Review and authorization to fabricate are only for general conformance with the design concept of the Project as expressed in the Contract Documents. Sole responsibility for the accuracy and completeness of this document, including but not limited to dimensions and quantities, remains with the Vendor/Contractor. HATCH does not warrant the accuracy or completeness of any of the information contained herein, nor does HATCH authorize or approve any construction means, methods, techniques, sequences or any safety precautions or procedures.			
HATCH N°/No. 316996-DF-PM503-001		R:	
CLIENT N°/No.		R:

PRELIMINARY
FOR APPROVAL
CHAMCO INDUSTRIES LTD.

TAHERA DIAMOND CORPORATION JERICHO DIAMOND PROJECT C/O HATCH LTD P.O. No. 316996-PM503		DESIGNED BY D.J.C.
Tag No. 150 DM-001 UNLOADING / TRANSFER FUEL MODULE		DRAWN BY B.L.
PROCESS FLOW DIAGRAM		CHECKED BY
DATE DEC. 13, 2004	SCALE N.T.S.	JOB No. 1010069ABS
DWG No. CUP1010074-02	REV. 0

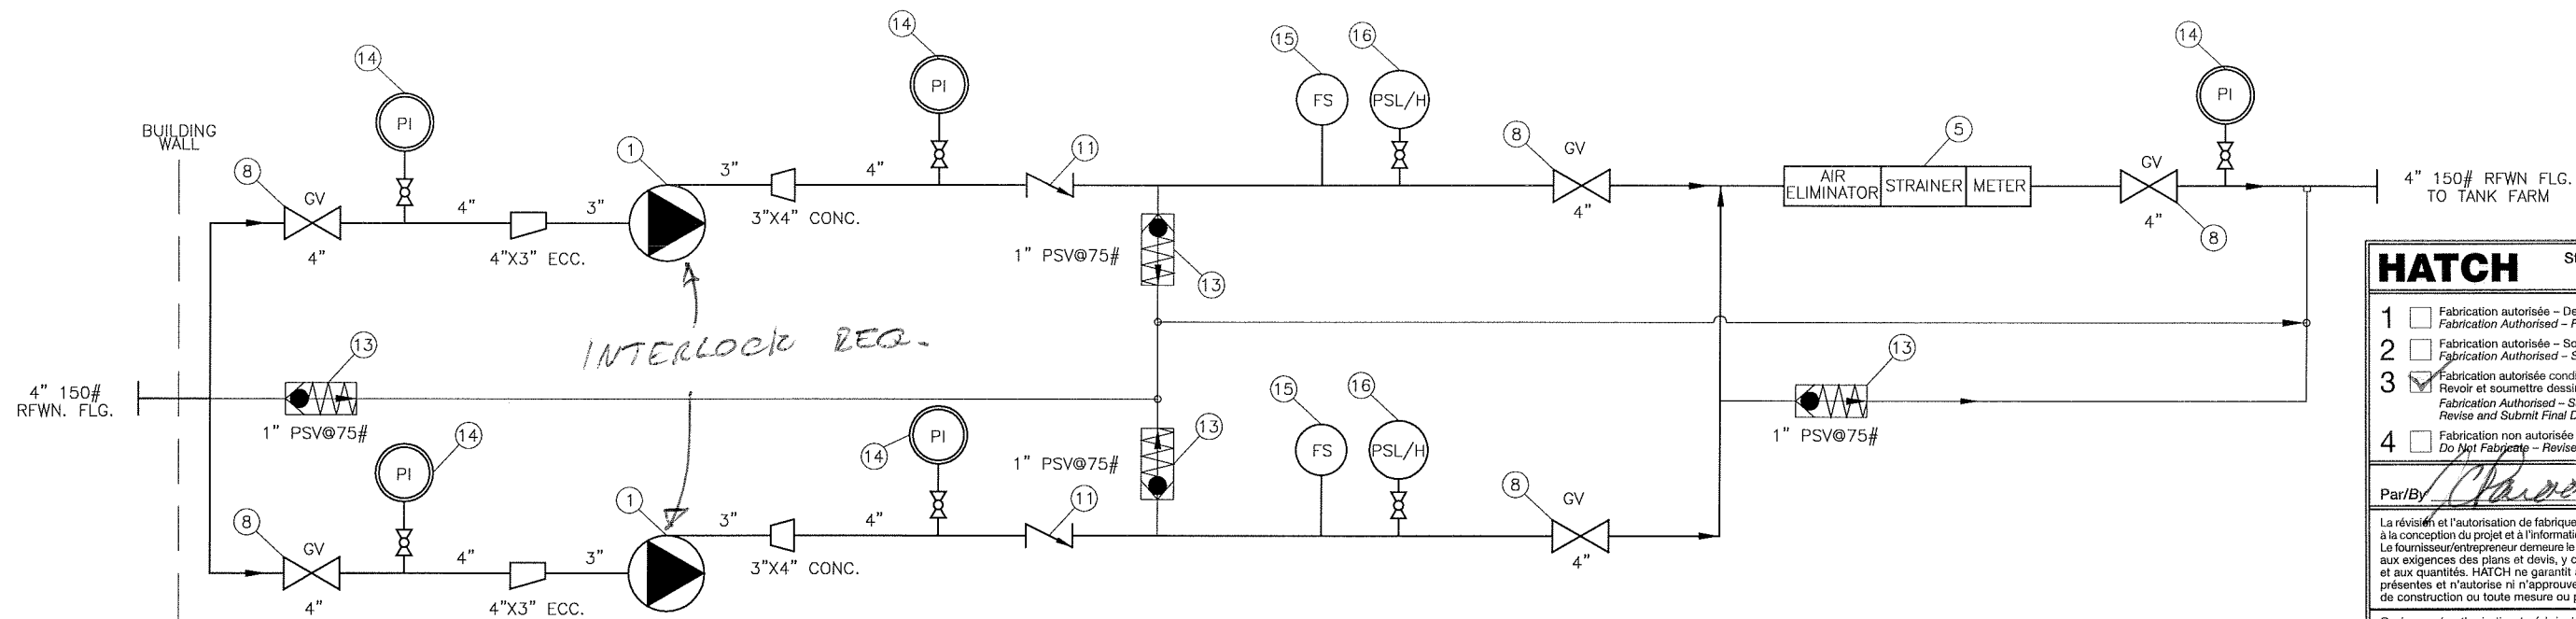
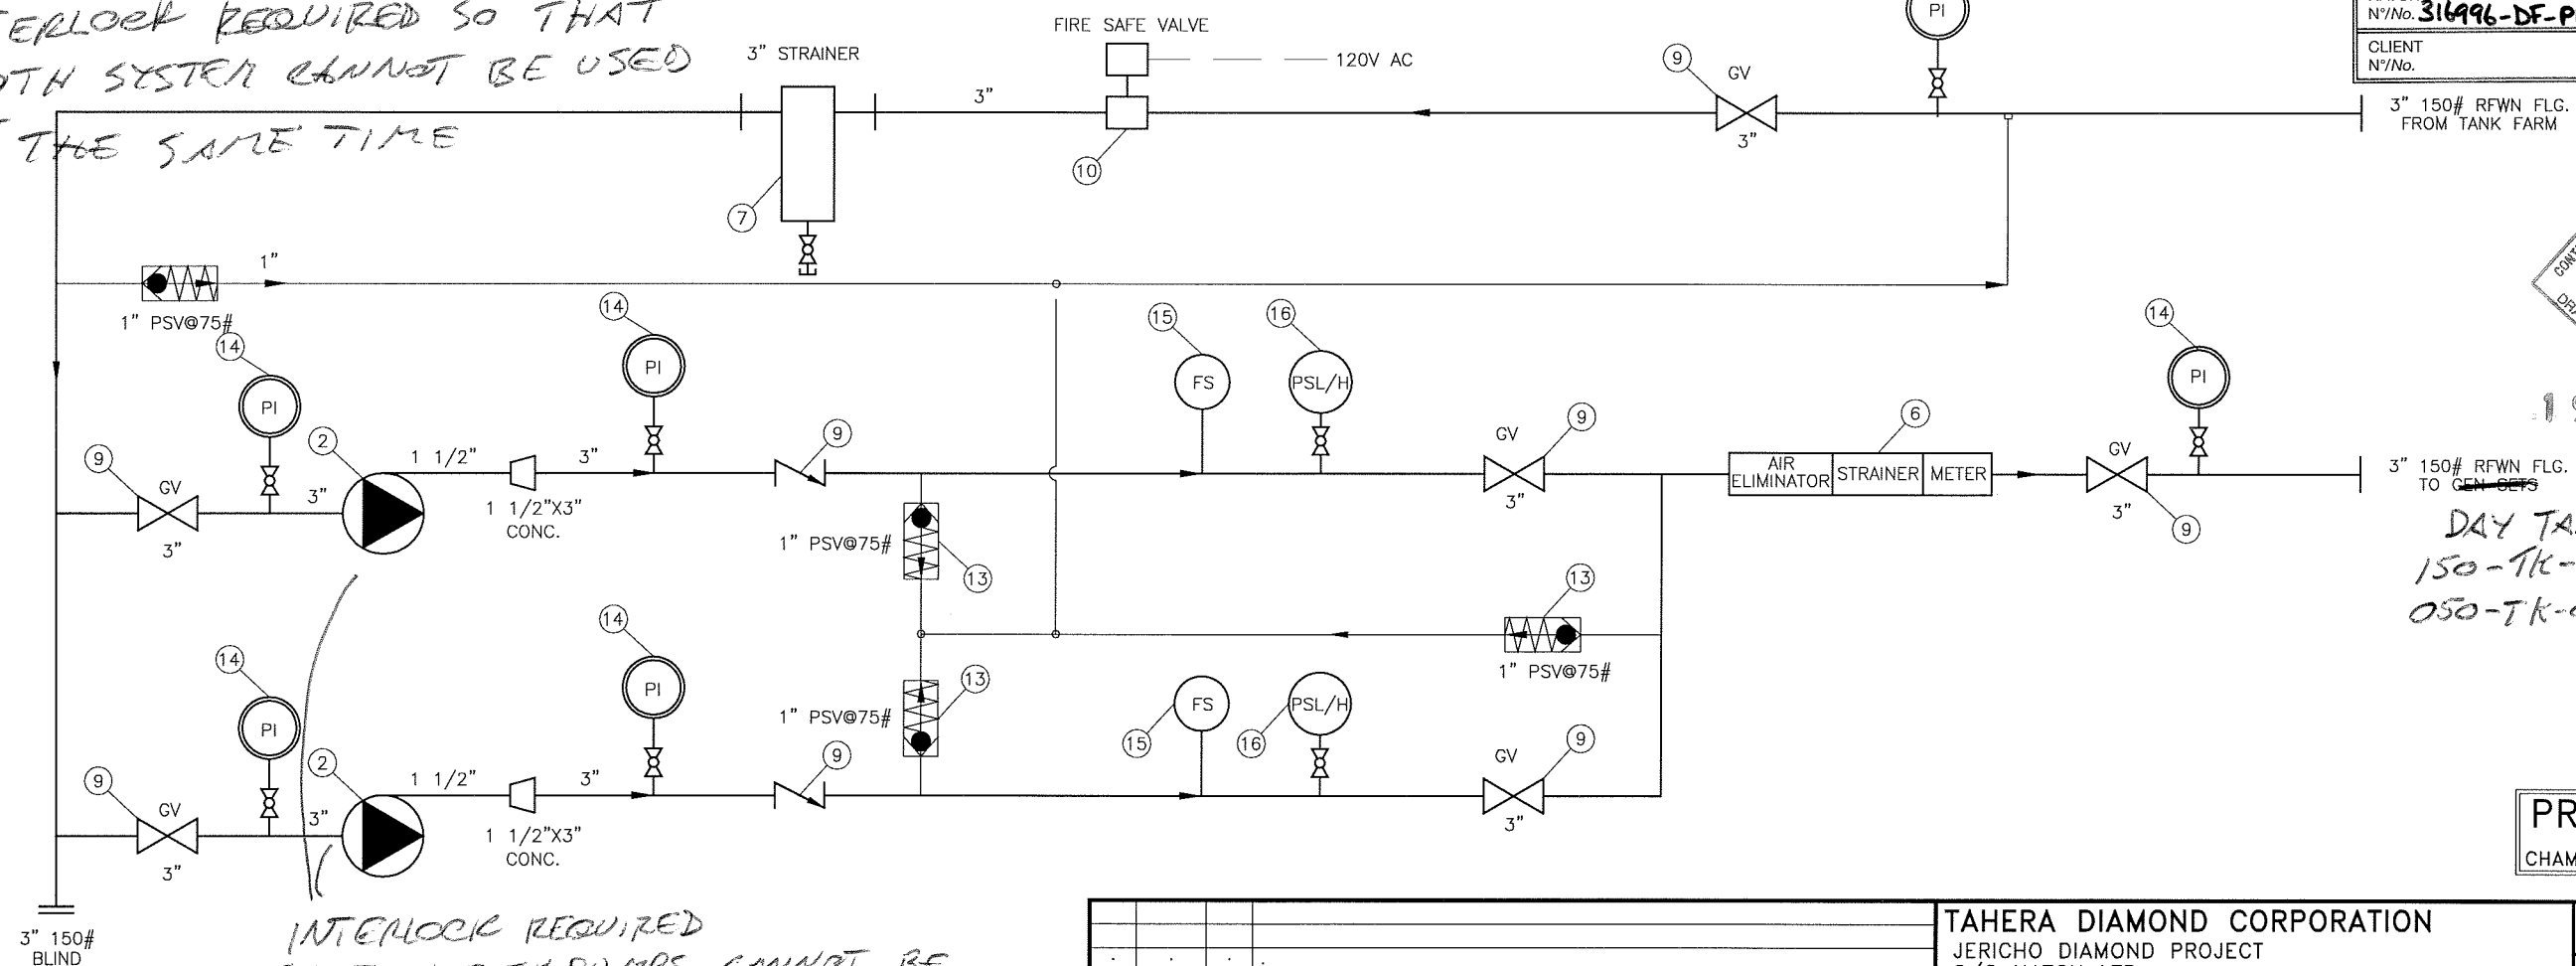
INTERLOCK REQUIRED SO THAT BOTH SYSTEM CANNOT BE USED AT THE SAME TIME

INTERLOCK REQUIRED SO THAT BOTH PUMPS CANNOT BE OPERATED AT THE SAME TIME
TRANSFER MODULE
